### Proposed Revisions to a Standard Plans Index

Index Number: 446-001

Index Title: Concrete Pavement Subdrainage

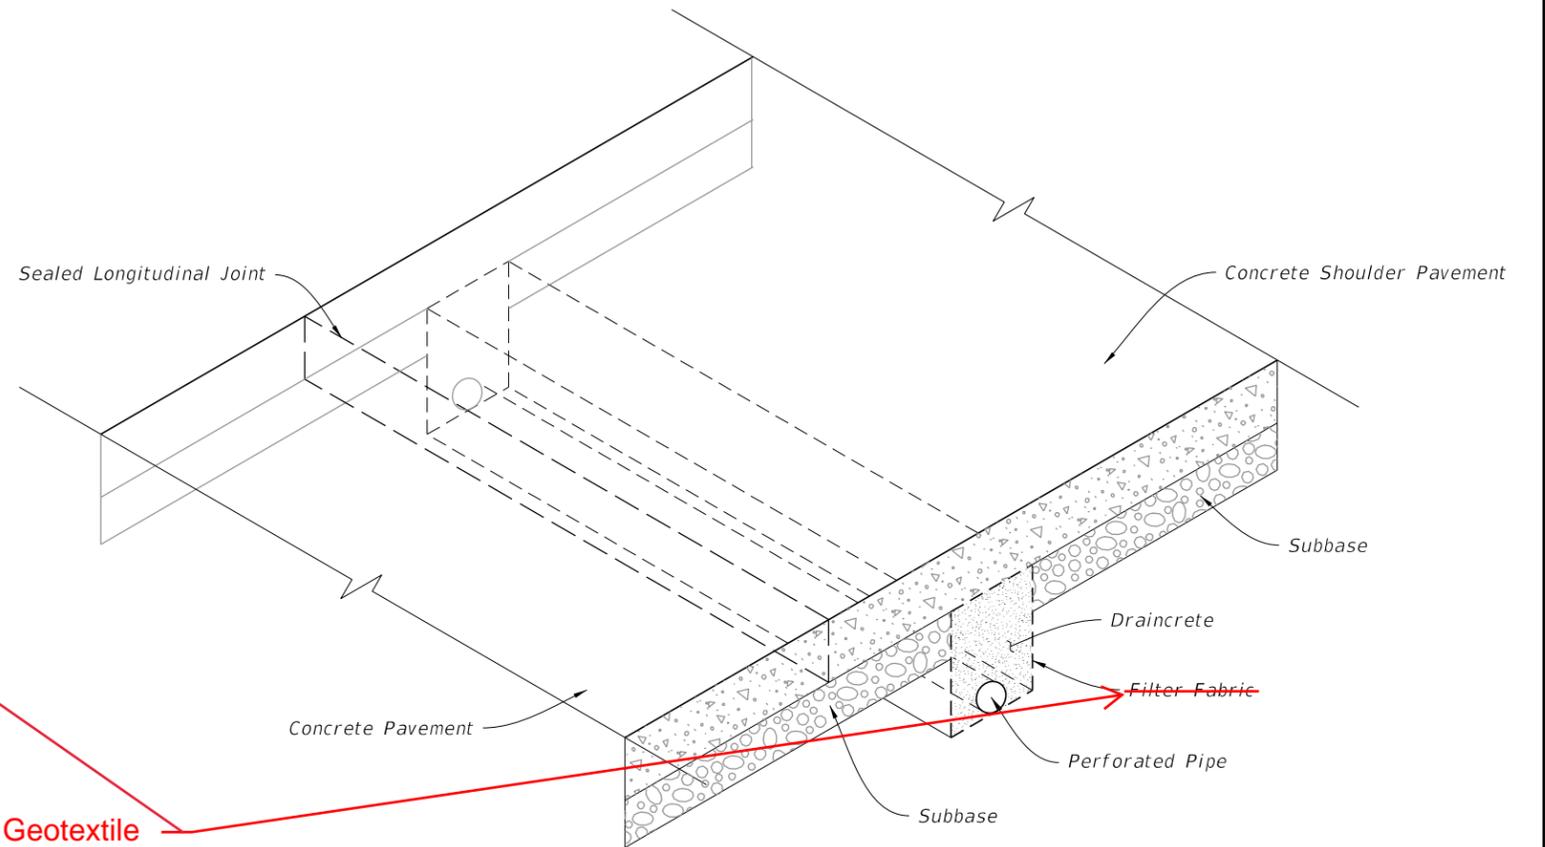
Sheet 1: Updated Note 4 "Provide and install Type D-3 geotextile in accordance with Specifications 514."  
Changed all references of "Filter Fabric" to Geotextile.

**UPDATED Note 4:**  
Provide and install Type D-3 geotextile in accordance with Specifications 514.

**CHANGED: Geotextile**

INDEX	SHEET
446-001	3 of 4

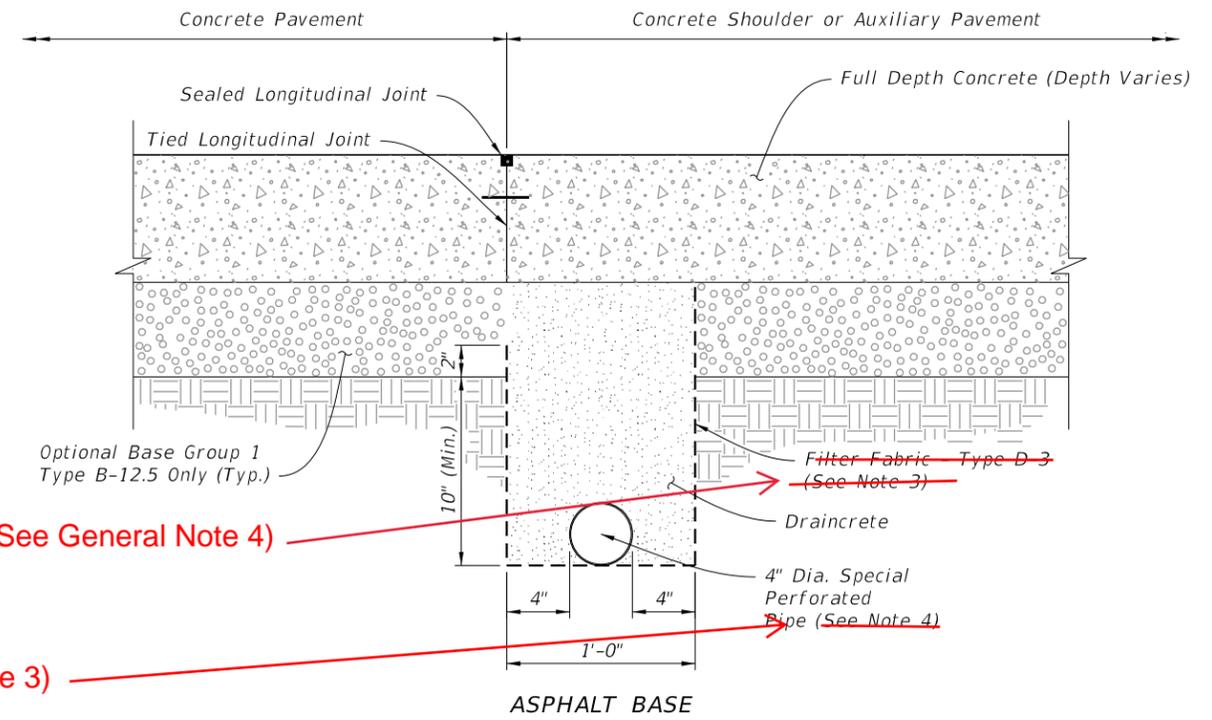
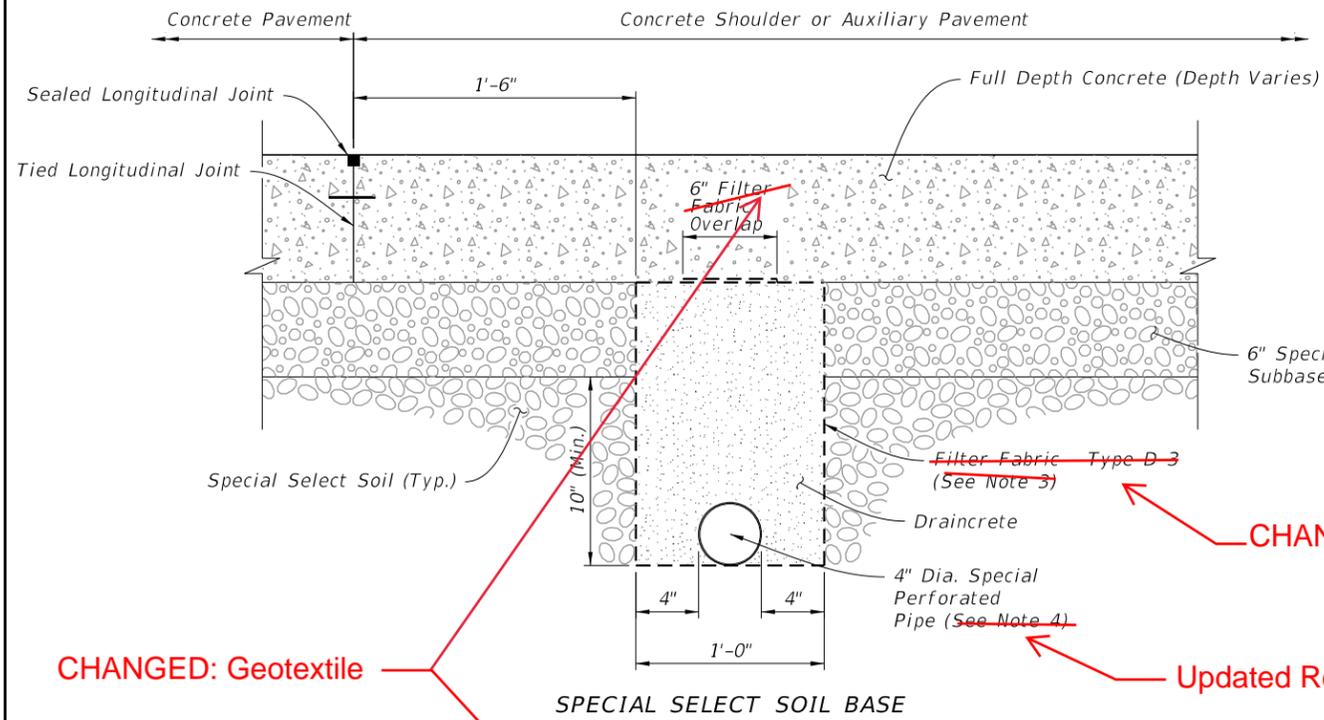
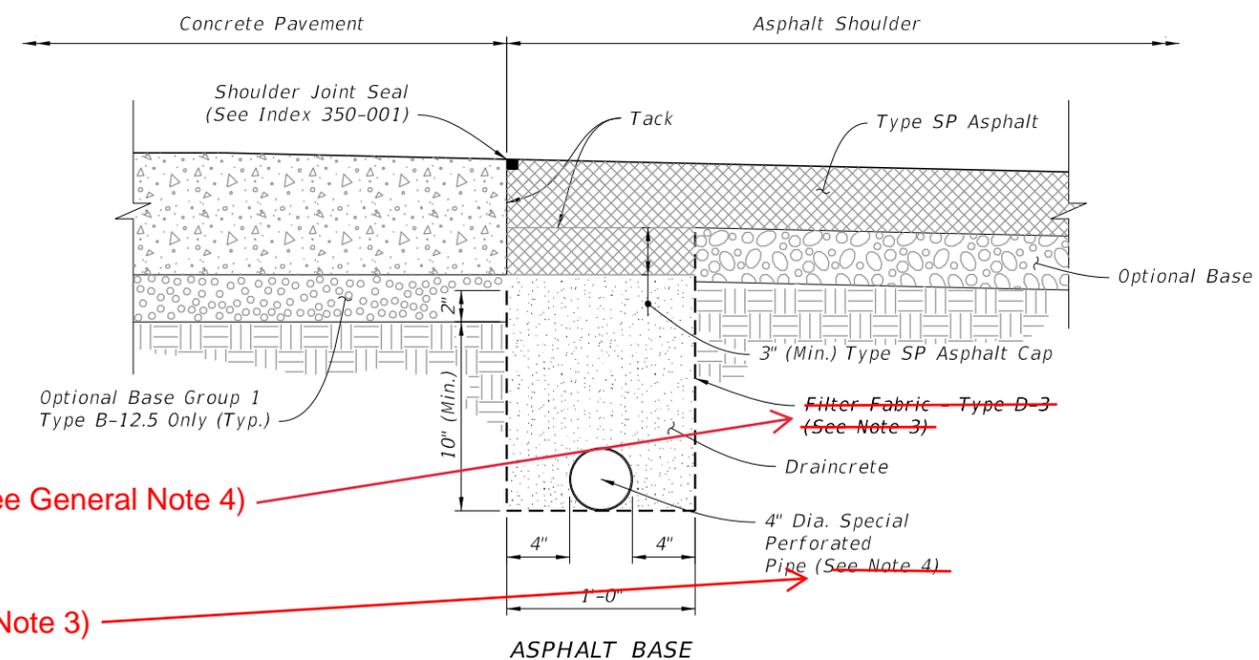
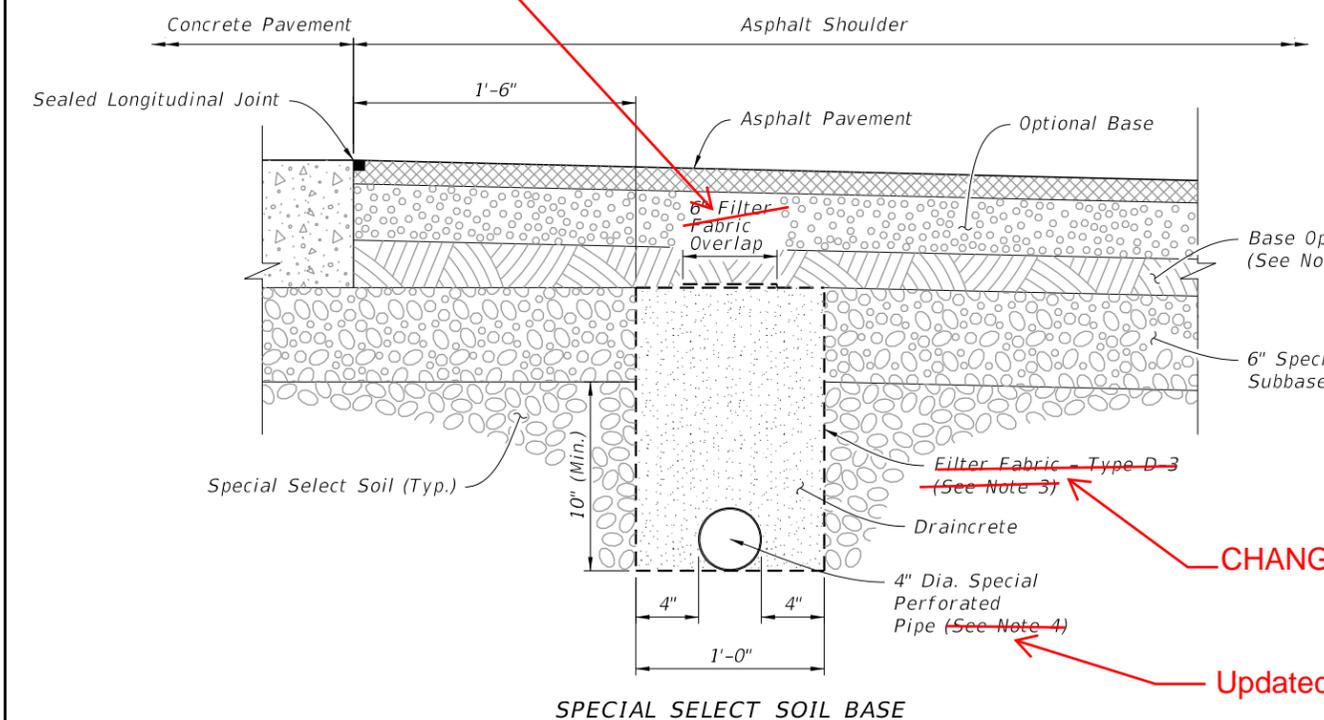
Sheet 3: Moved Note 3 to General Note 4 on Sheet 1; Renumbered Notes; Updated Note references in callout;  
Changed all references of "Filter Fabric" to "Geotextile".

CHANGED: Geotextile

CHANGED: Geotextile (See General Note 4)

Updated Reference: (See Note 3)

CHANGED: Geotextile (See General Note 4)

Updated Reference: (See Note 3)

Renumbered Notes

INDEX 446-001	SHEET 4 of 4
------------------	-----------------

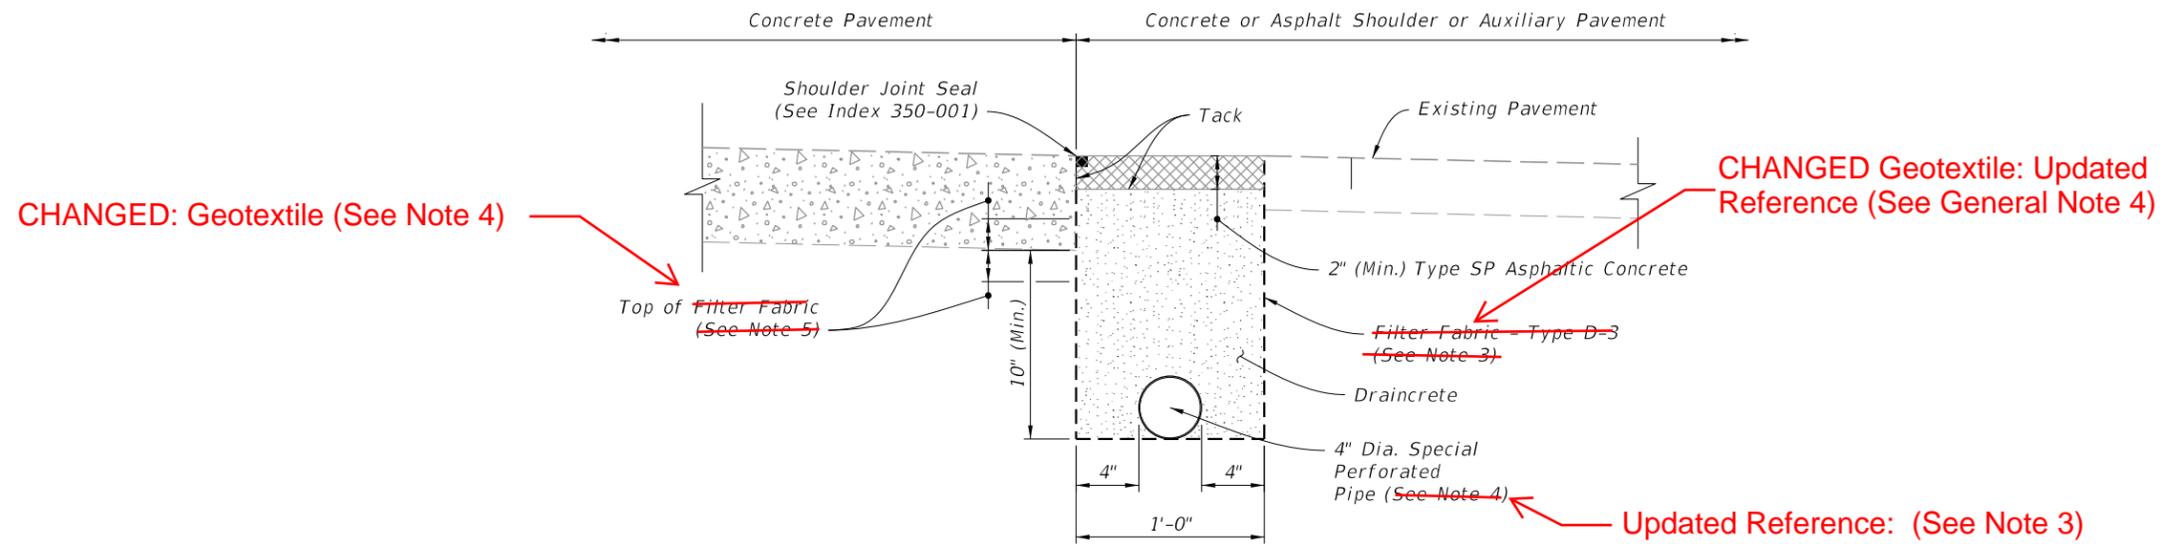
Sheet 4: Moved Note 3 to General Note 4 on Sheet 1; Renumbered Notes; Updated Note references in callout;  
Changed all references of "Filter Fabric" to "Geotextile".

Renumbered Notes

CHANGED: Geotextile
